CVEC ROUND 5 RFP Questions/Answers

CVEC Round 5 PV/Storage RFP Answers to Vendor Questions – 11.5.19

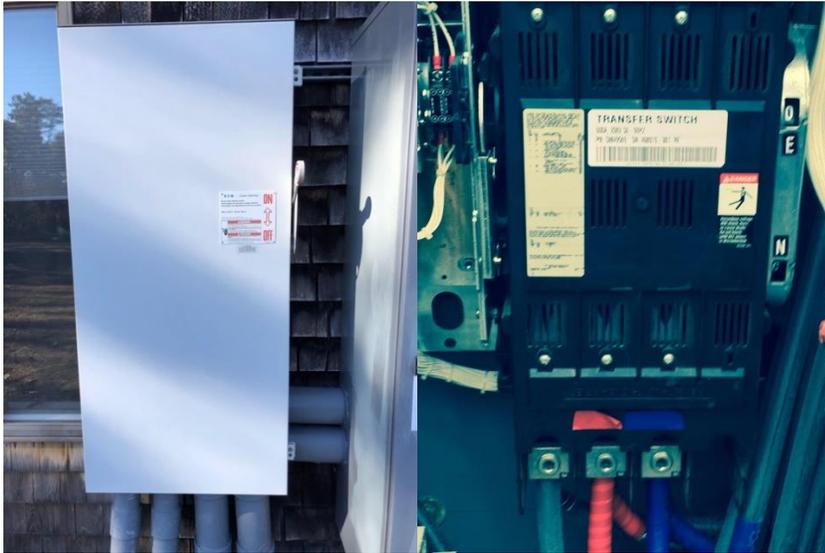
23) For the **Chatham Recreation Center** project, what is the location of the utility meters and CTs? **A diagram is below:**
